Appendix A

Notice of Preparation and Responses

PROJECT NAME: California Flats Solar Project

RE: Scoping Comments on the Notice of Preparation (NOP) of an Environmental Impact Report for the California Flats Solar Project Development Application, Planning File Number: PLN120294.

VIEW OF CHALAME VALLEY (PROPOSED CALIF. FLATS SOLAR FIELD) FROM OROPESA RANCH
RESIDENCE

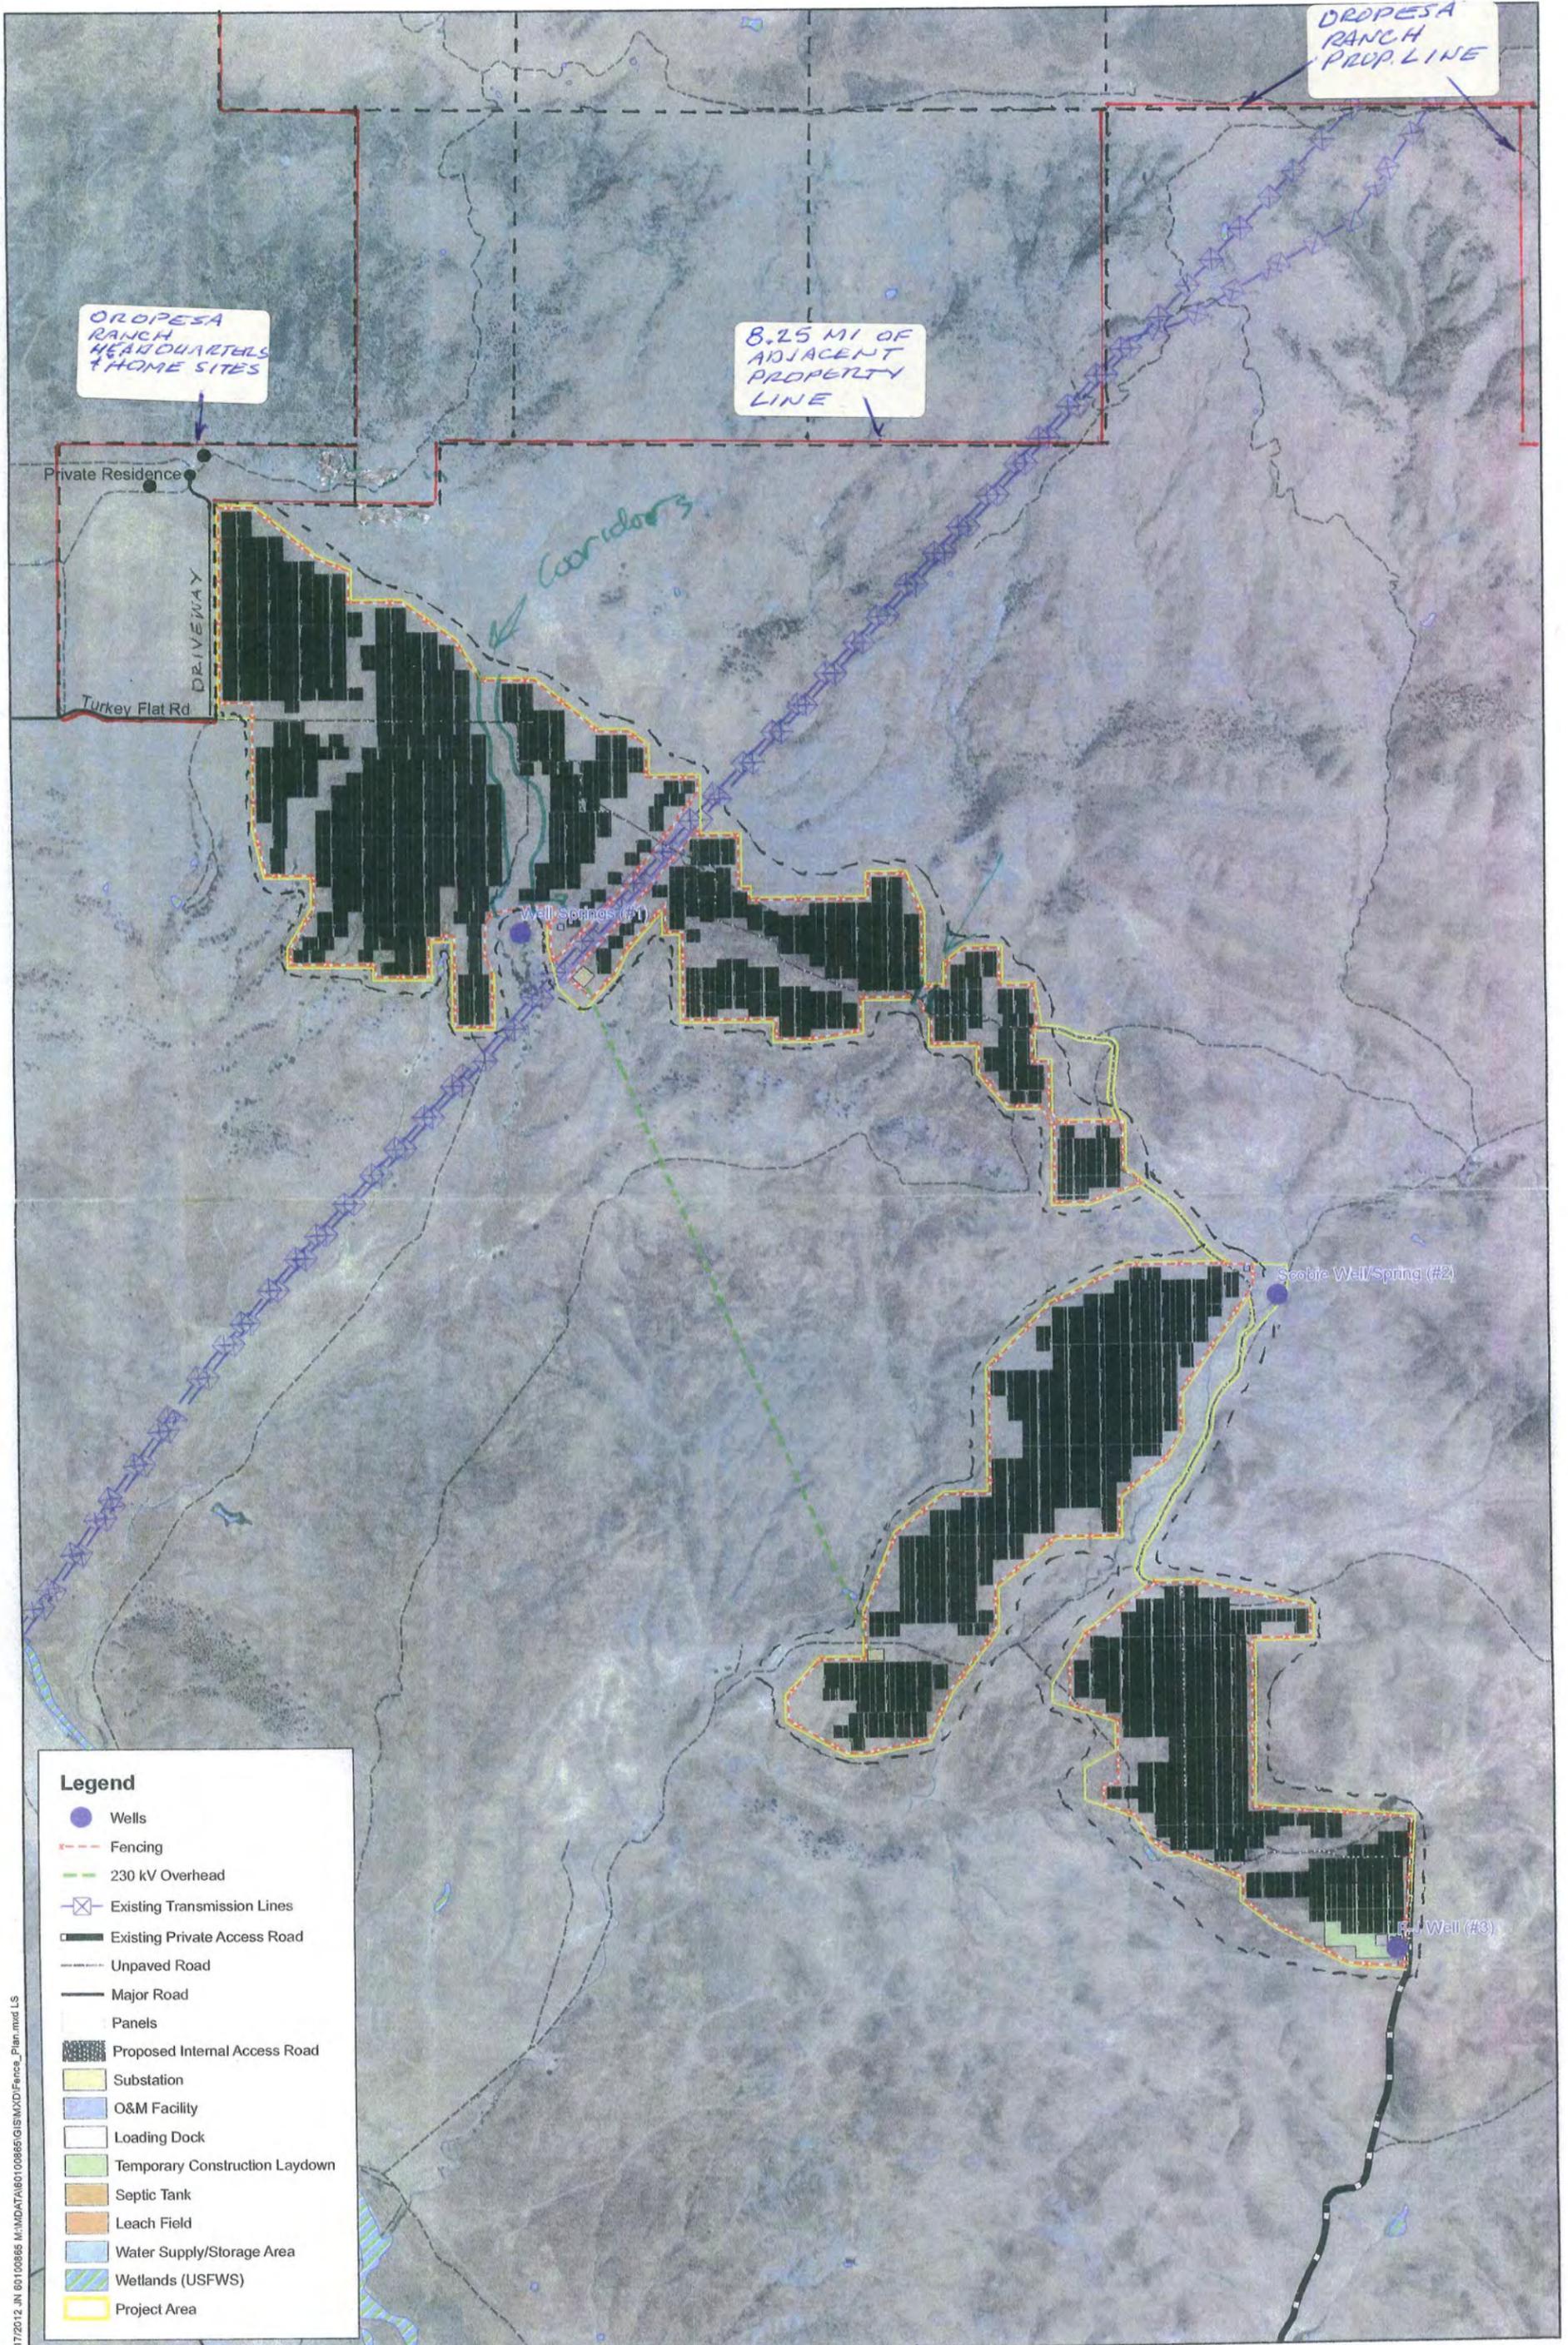
- a). visually-aesthetically we will be able to see the industrial nature of the solar field from almost everywhere on our ranch. There will be no escaping the contrary nature of the solar field stretching out miles below us.

Enclosed is map showing part of 8.25 miles of our property line adjacent to the project boundaries and pictures of the view from our home.
